PD Modification Application: PRS 25-0315

**Hillsborough
County Florida**

Development Services Department

AGENCY REVIEW COMMENT SHEET

2.3 Approved Site Plan (partial provided below for size and orientation purposes. See Section 8.1 for full site plan)

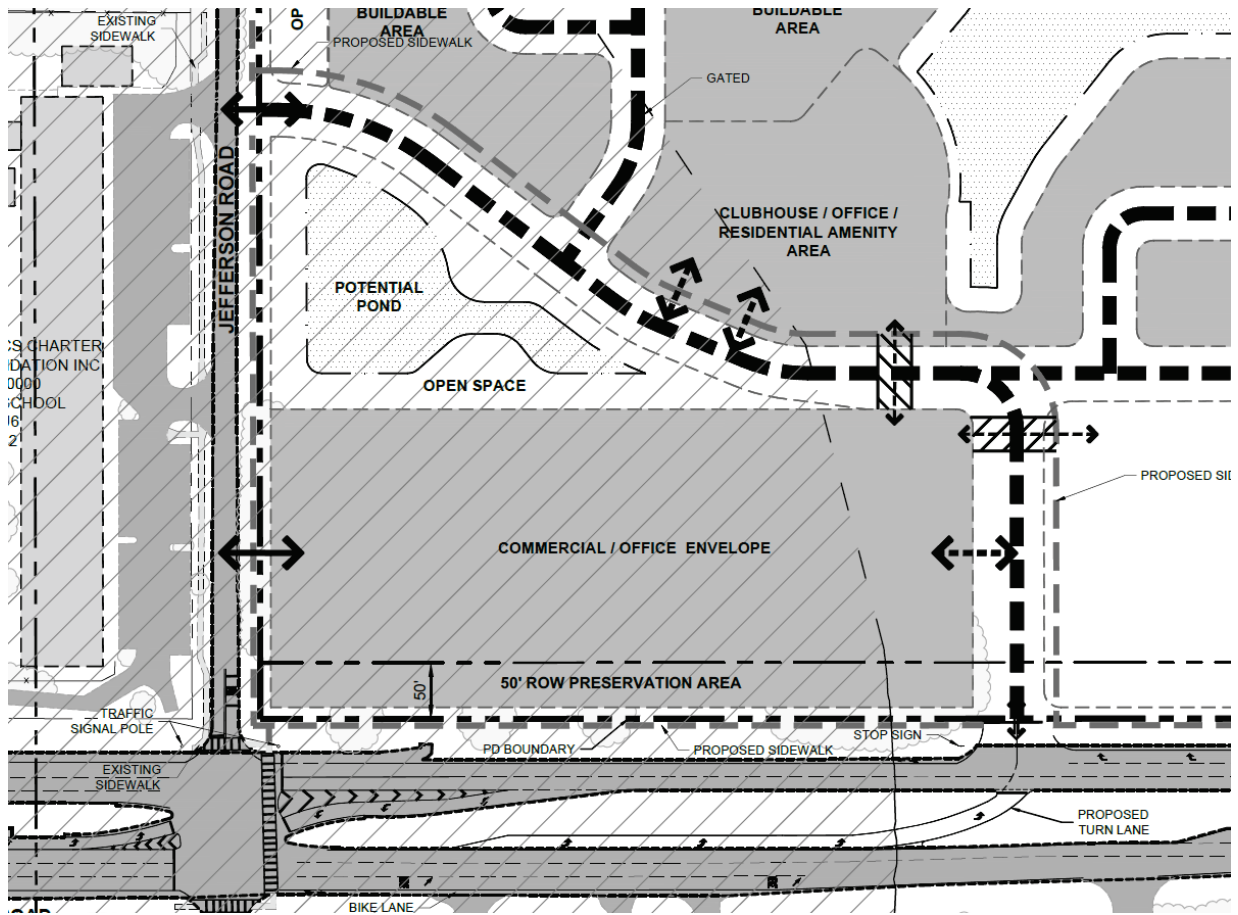
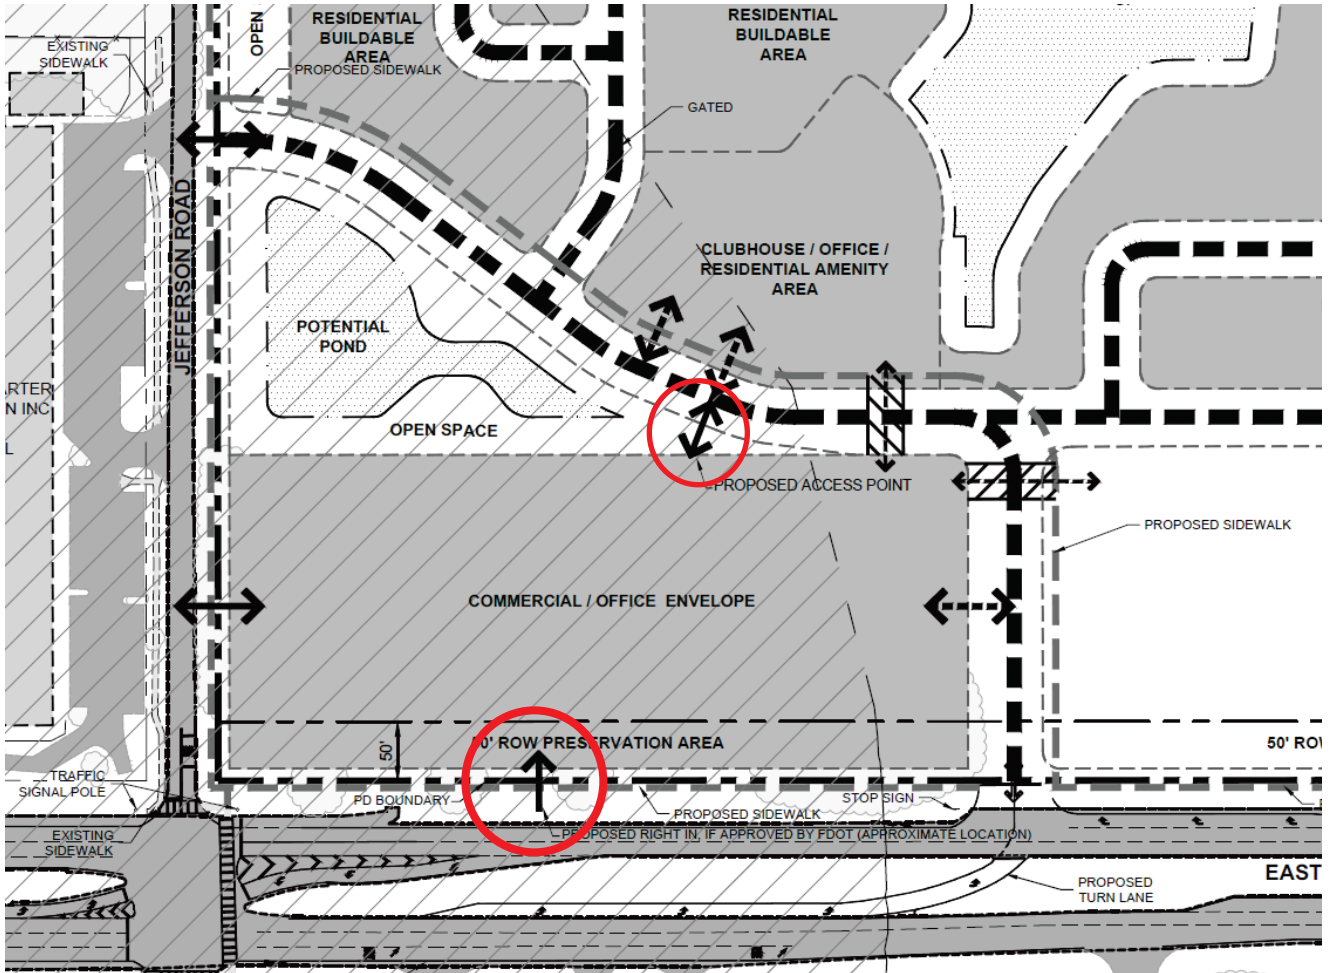
Existing Approval(s):	Proposed Modification(s):
No internal access point along the north side of the Commercial/Office envelope.	New internal access along the north side of the Commercial/Office envelope.
One access point permitted on Fowler Avenue (outside of the Commercial/Office envelope). One access point in total to Fowler Ave. for the entire PD.	Add additional access point on Fowler Ave. for the Commercial/Office envelope. Two access points in total to Fowler for the entire PD.
No condition regarding the LDC regulations regarding signage within a ROW preservation area.	Include a condition that states that temporary signage is allowed within the ROW preservation area, subject to LDC requirements.
Northbound left turn lane on Walker Road required.	State that this condition has been satisfied.

- Add an access internally, along the north side of the Commercial/Office Envelope;
- Add a potential right-in only access to Fowler Ave., between the primary project access on Fowler Ave. and Jefferson Rd., the presence and location of which is subject to FDOT review and approval; and,
- Clarify that temporary signage is allowed within the right-of-way preservation area, subject to the requirements of the LDC.

FIGURE 1

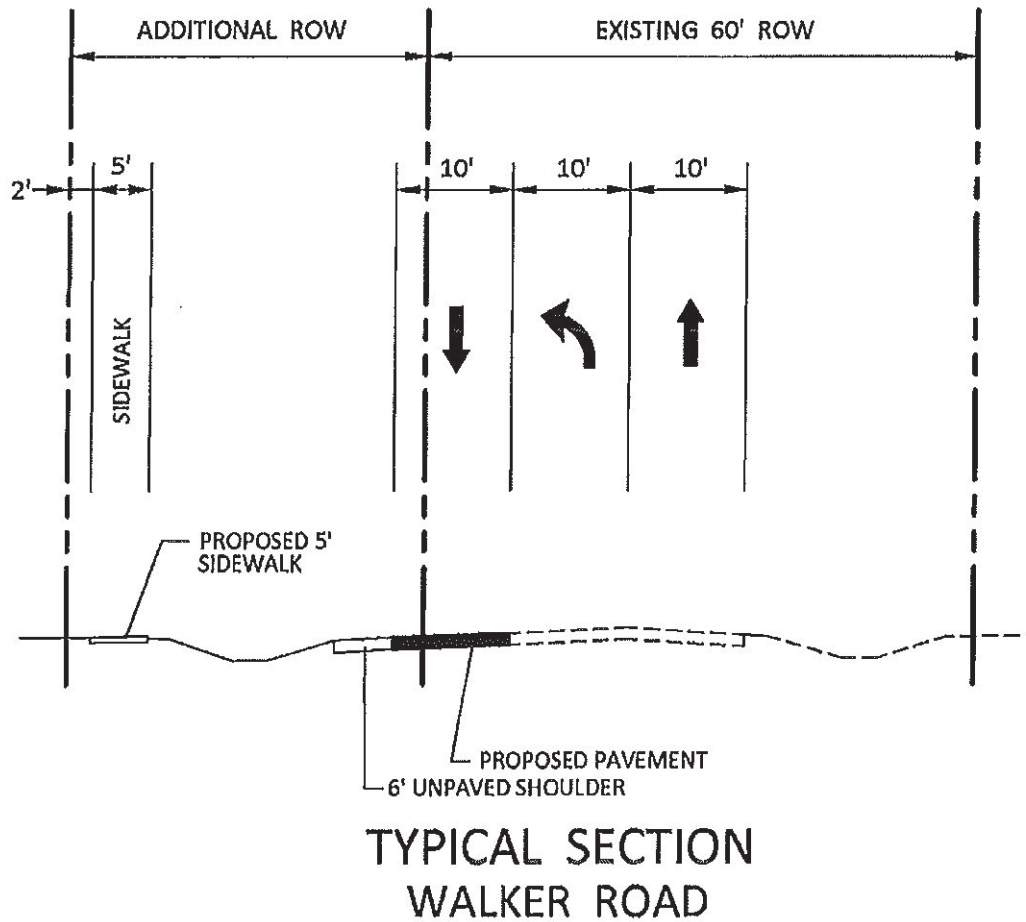
The access to Walker Road is proposed to be full access to serve the Multi-Family only. The following provides the Design Exceptions required for the project:

- 1) Right of Way – TS-7 has 96 feet of right of way. The existing right of way along Walker Road is approximately 60' feet. The developer proposes to provide additional right of way along the westside of the roadway to provide the access improvements.

- 2) Lane Width – TS-7 has 12 foot lanes. The existing road has 10 foot travel lanes. The 10 foot travel lanes are justified for the following reasons:

Figure 1 illustrates the proposed typical section.

The County Engineer has reviewed zoning modification application # 25-0315 and determined the changes to be de minimis. As such, the previous approval shall stand.

FIGURE 2

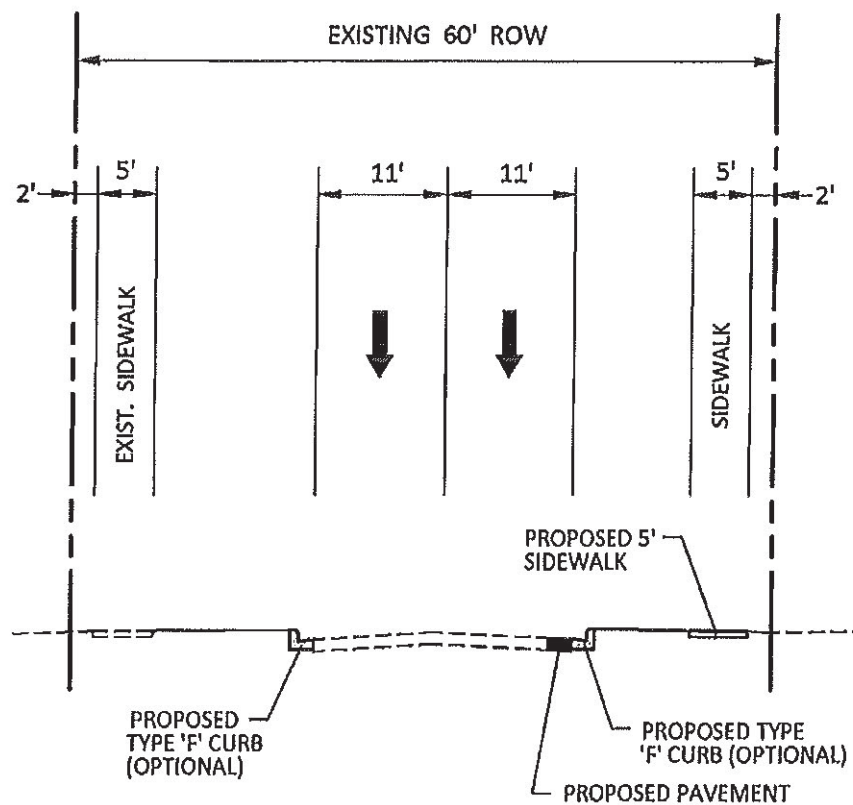
- 1) Right of Way – TS-7 has 96 feet of right of way. The existing right of way along Jefferson Road is approximately 60' feet. The developer does not own or control the right of way along the west side of the road.

- 2) Lane Width – TS-7 has 12 foot lanes. The existing road has 10 foot travel lanes. The 10 foot travel lanes are justified for the following reasons:

Figure 2 illustrates the proposed typical section.
